Accessibility Design Statement

Prepared for: Redland Investment Corporation c/- Codicote
Job No: 220205
Date: 07th March 2022
Phase: Stage 3A
Revision: 1

The proposed Weinam Creek redevelopment project in Redland Bay will feature the following:

APPENDIX A – DRAWING MARK-UP

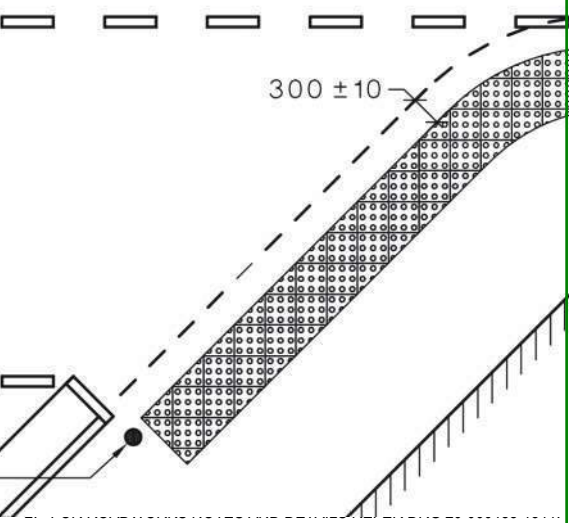
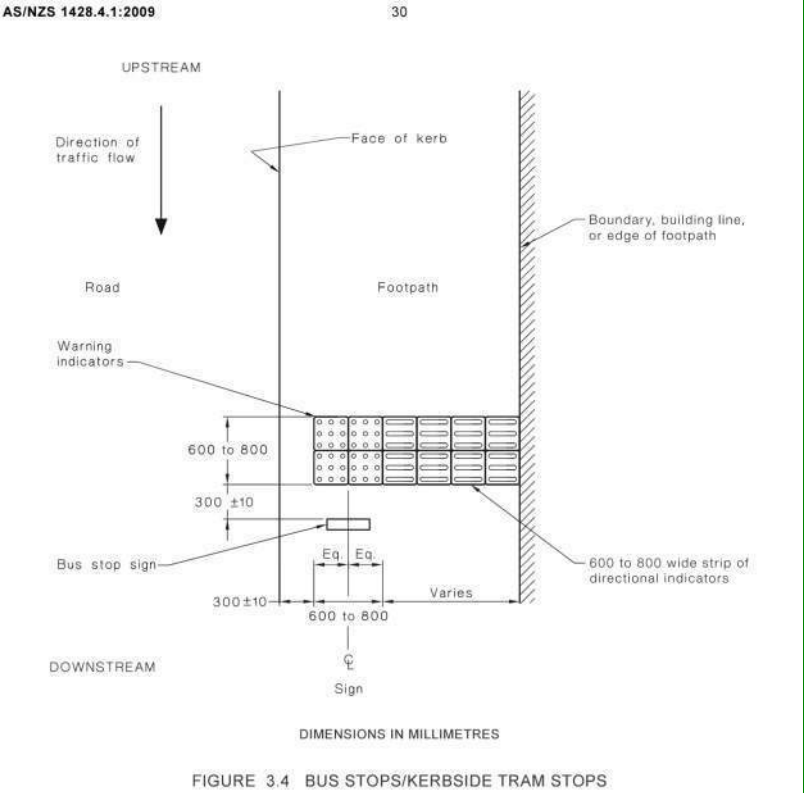
DSAPT Requirement - Bus Stop Layout

Ensure as the design develops compliant bus stop layout is provided in accordance with AS 1428.4.1 2009 (required layout below and opposite with a bus shelter) - recognising the proposed departure from DSAPT with the design complying with current Standards in lieu of AS 1428.4 1992.

Further assessment required as to footpath width to the southern side of Hamilton Street, recognising the existing stop comprises a shelter, with a 1200mm clear path width required.

DDA Recommendation - Pedestrian Crossing

AS 1428.4.1 seeks for provision of TGSi's at vehicular crossings. Clarification required as to whether the proposed commercial crossings will be provided accordingly.

DDA Recommendation - Pedestrian Crossing

AS 1428.4.1 seeks for orientation of TGSi's to align with the direction of travel (extract of Figure C9(C) above). As the design develops allow for TGSi layout to provide clarity as to direction of crossing in alignment with the arrow detailed from the western side recognising the curvature of the footpath.

Additionally allow for the design to detail kerb ramps to the crossing in accordance with AS 1428.1 2009 and Redland City Council / TMR robust details.
